June 9, 2023

City of Aurora
Planning and Development Services Dept
15151 E. Alameda Parkway, Suite 2300
Aurora, CO 80012

**RE: Antelope Creek (Kings Point North) 2nd Submission Review Response to Comments
CN#: 2022-6050-00; 2022-3081-00**

TYPICAL TRAIL CROSS-SECTIONS

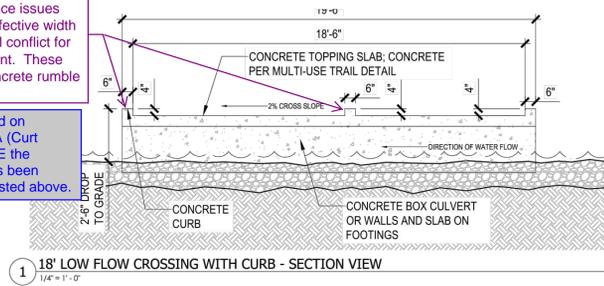
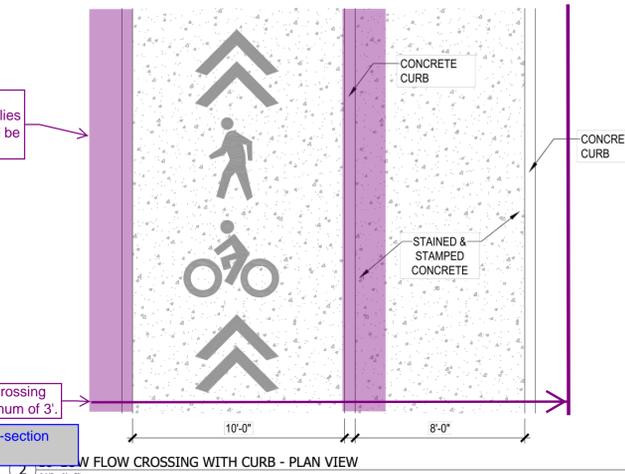
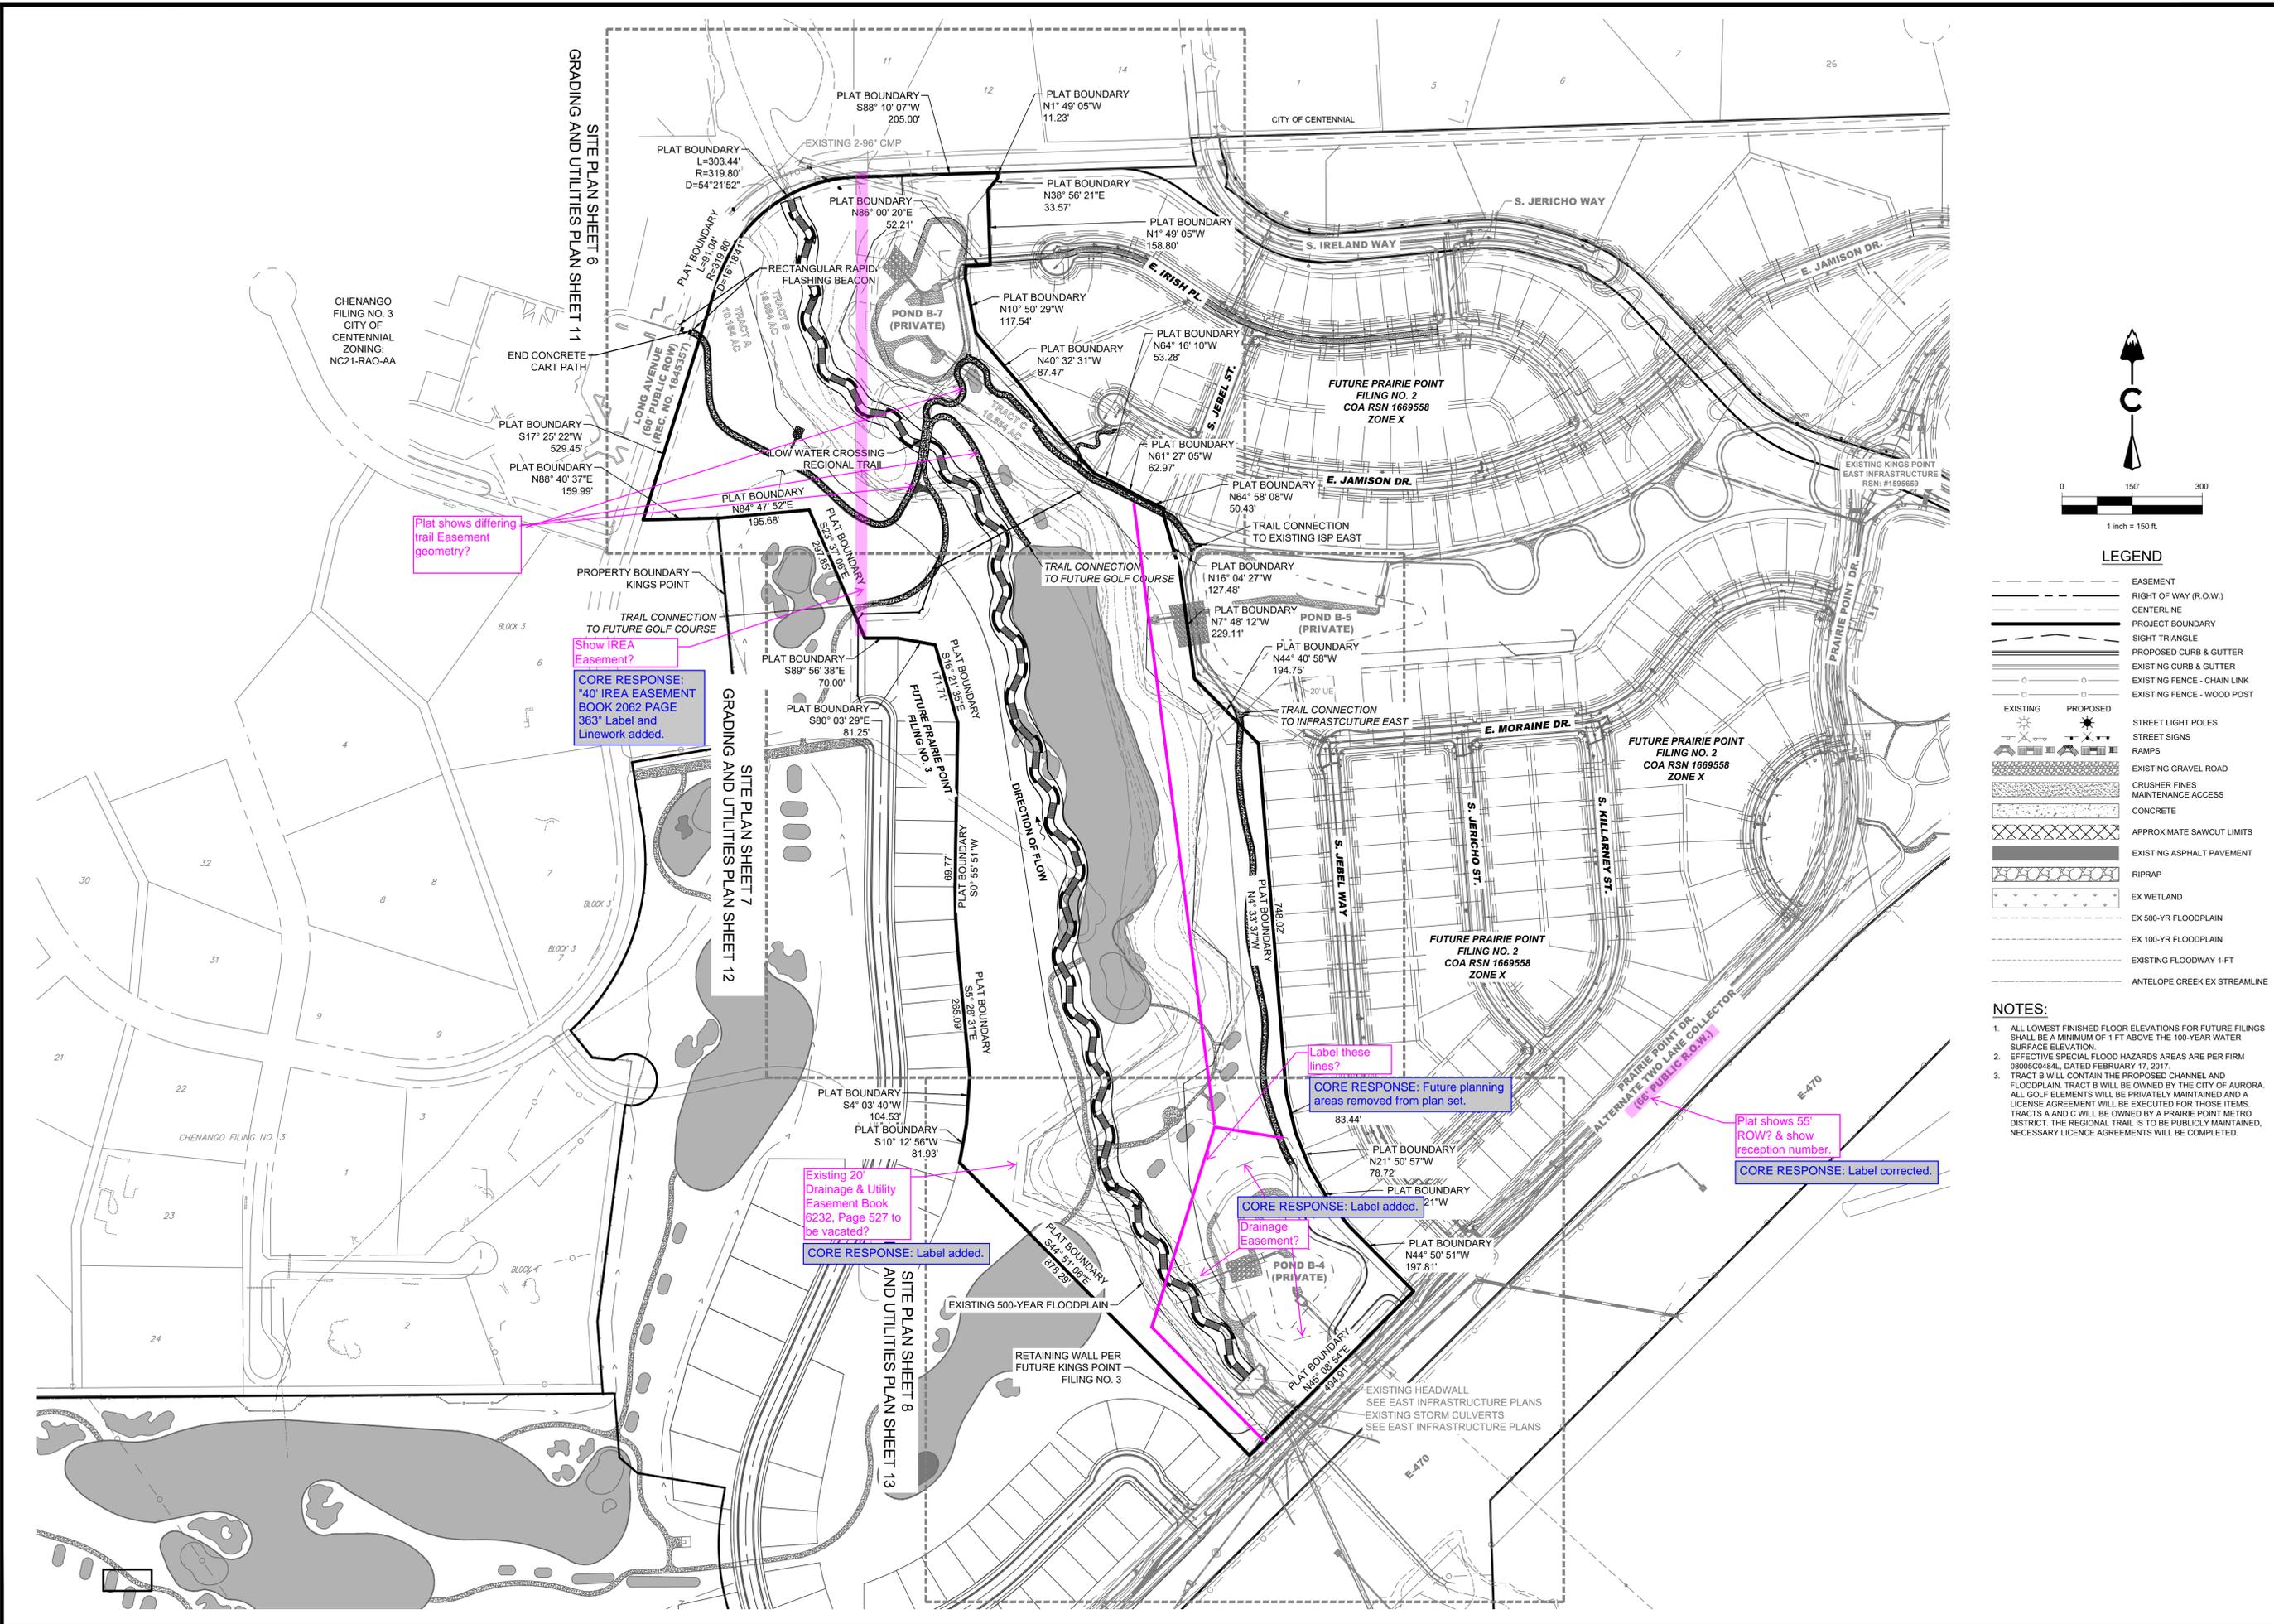
- a. Just as the regional trail is required to provide a recovery zone on either side, the same rule applies to the low water crossing. Rumble strips should be integrated into each 2' space.

- b. Vertical features, such as the proposed curbs, are hazards to trail users. They also create shy-away distance issues which result in a reduced effective width of the trail, causing potential conflict for opposing trail user movement. These should be replaced with concrete rumble strips.

- c. The width of the low water crossing must be widened by a minimum of 3'.

Vertical features, such as the proposed curbs, are hazards to trail users. They also create shy-away distance issues which result in a reduced effective width of the trail, causing potential conflict for opposing trail user movement. These should be replaced with concrete rumble strips.

Just as the regional trail is required to provide a recovery zone on either side, the same rule applies to the low water crossing. Rumble strips should be integrated into each 2' space.

The width of the low water crossing must be widened by a minimum of 3'.

RESPONSE: Revised design for the low water crossings, including the rumble strips, have been added to the set for approval.

RESPONSE: Based on discussions with Curt Bish and the design team, the vertical curb is preferred to protect the safety of pedestrians and cyclists from potential conflict with golf carts. As an acknowledgement for the safety concern noted by COA, we have added an additional rumble strip to warn trail users prior to hitting any vertical curb.

RESPONSE: Revised

CORE RESPONSE: Based on conversation between COA (Curt Bish), Terracina, and CORE the proposed cross-section has been modified to specifications listed above.

CORE RESPONSE: Based on conversation between COA (Curt Bish), Terracina, and CORE the proposed cross-section has been modified to specifications listed above.

CORE RESPONSE: Cross-section widened to 23'.

ANTELOPE CREEK INFRASTRUCTURE SITE PLAN
GRADING PLAN 1

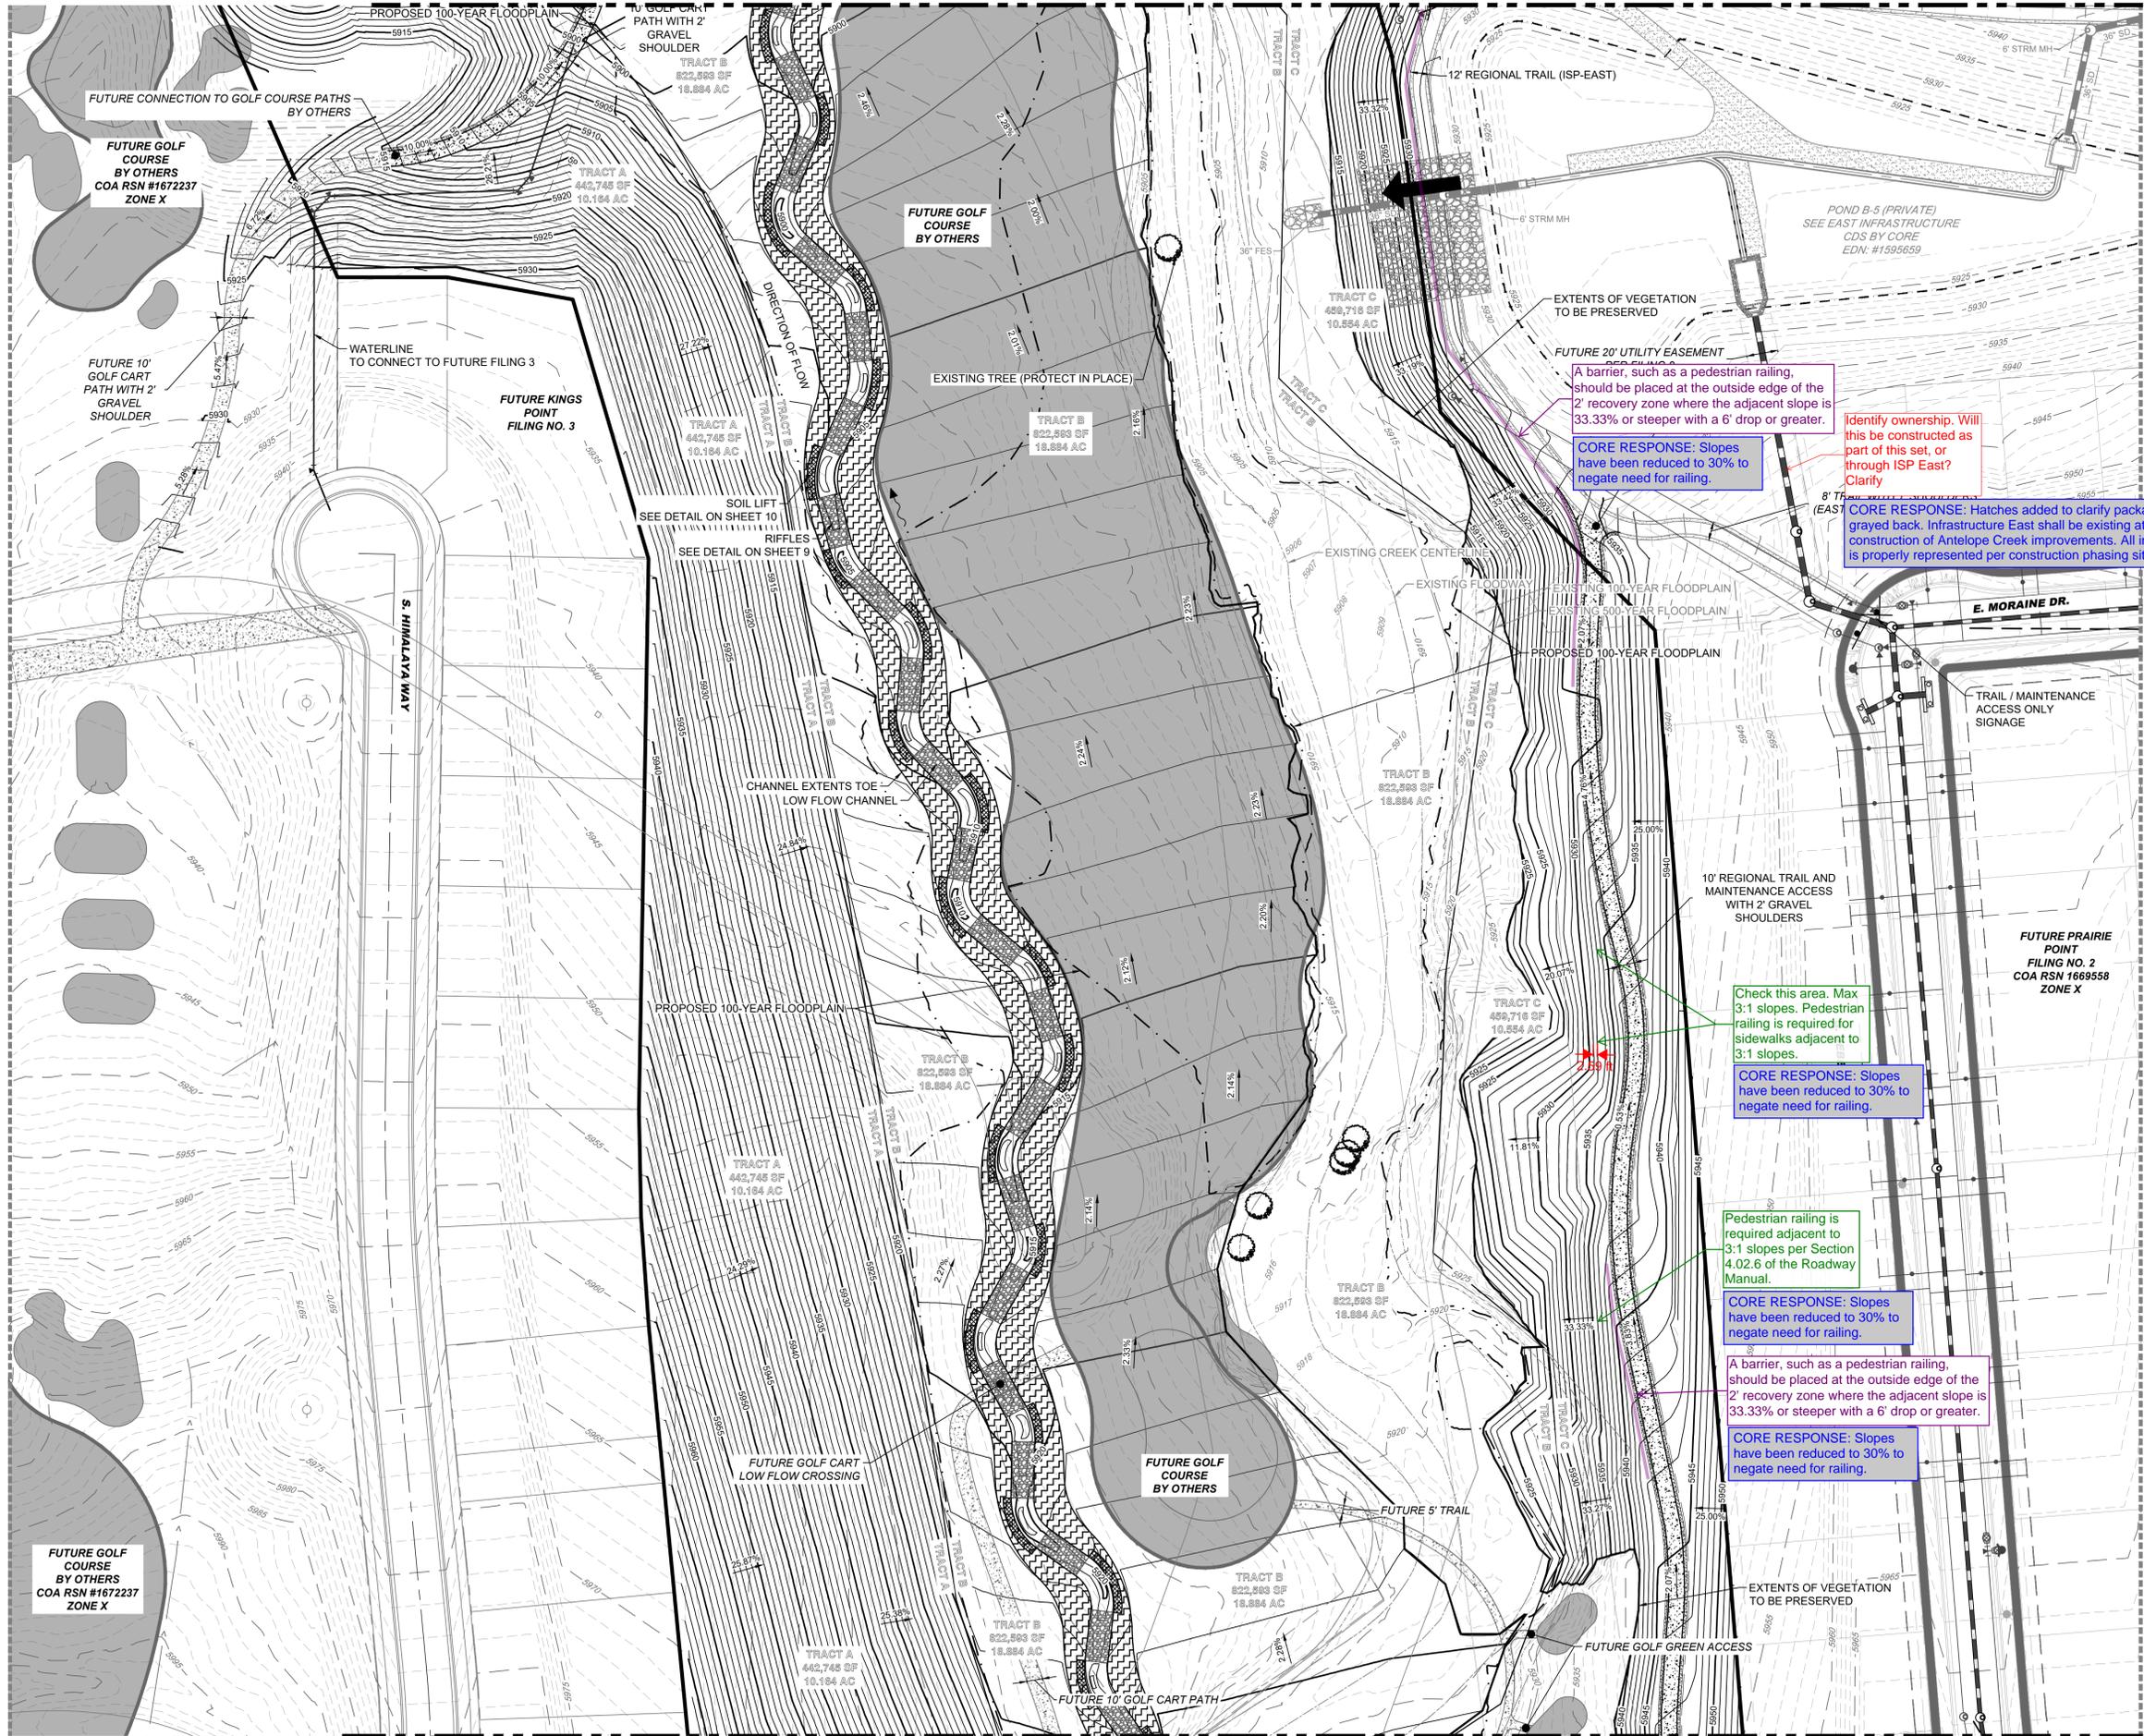
- a. Pedestrian railing is required adjacent to 3:1 slopes per Section 4.02.6 of the Roadway Manual.
RESPONSE: Noted. Per discussions with Curt Bish and the City of Aurora, slopes adjacent to trails and pathways have been reduced to be less than 3:1 to eliminate the need for additional handrail.

- f. The proposed grading in these areas don't appear to be a constraint limiting the ability to eliminate some bends in the trail.

- g. The rear lot lines of the homes are too close to the trail. Ideally, a 30' setback from property lines and fences should be provided, but in this instance a 20' setback would be accepted.

- h. A barrier, such as a pedestrian railing, should be placed at the outside edge of the 2' recovery zone where the adjacent slope is 33.33% or steeper with a 6' drop or greater.

A barrier, such as a pedestrian railing, should be placed at the outside edge of the 2' recovery zone where the adjacent slope is 33.33% or steeper with a 6' drop or greater.

Identify ownership. Will this be constructed as part of this set, or through ISP East? Clarify

Check this area. Max 3:1 slopes. Pedestrian railing is required for sidewalks adjacent to 3:1 slopes.

Pedestrian railing is required adjacent to 3:1 slopes per Section 4.02.6 of the Roadway Manual.

RESPONSE: The alignment of the trail has been revised based on discussions with COA. We continue to be constrained by the existing floodplain, detention pond, and ADA accessibility, however, the proposed alignment provides the best possible solution to meet all of these goals.

RESPONSE: Per discussions with COA, this trail sits vertically separated from the rear lots by a proposed retaining wall. Our site is constrained by the floodplain and a desire to preserve the existing vegetation in the corridor. The wall provides a practical separation from the homes to alleviate this concern.

RESPONSE: Noted. Per discussions with Curt Bish and the City of Aurora, slopes adjacent to trails and pathways have been reduced to be less than 3:1 to eliminate the need for additional handrail or rumble strips.

CORE RESPONSE: Slopes have been reduced to 30% to negate need for railing.

CORE RESPONSE: Hatches added to clarify packages. Filing 2 grayed back. Infrastructure East shall be existing at the time of construction of Antelope Creek improvements. All infrastructure is properly represented per construction phasing site-wide.

CORE RESPONSE: Slopes have been reduced to 30% to negate need for railing.

CORE RESPONSE: Slopes have been reduced to 30% to negate need for railing.
